Product Change Notice

June 2020

Tadiran Batteries has decided to change the insulation disc of TL(H)-2450.
This will affect the whole model range of the product and will be put into production from the second half-year 2020 onwards.

Models: TL-2450/P with disc; Catalogue No. 11 1 13763 02 and
TLH-2450/P with disc; Catalogue No. 11 1 15763 02.

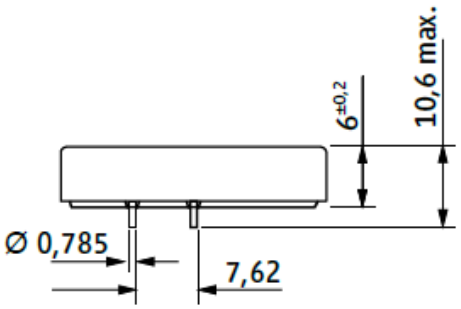
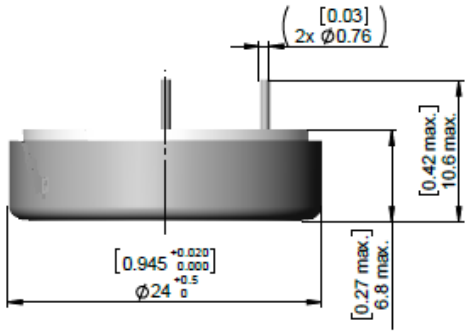
The new insulation disc is up to 0.8mm thicker. This also effects the available length of the pins by 0.8mm.

The appearance could either be with or without visible extraction points
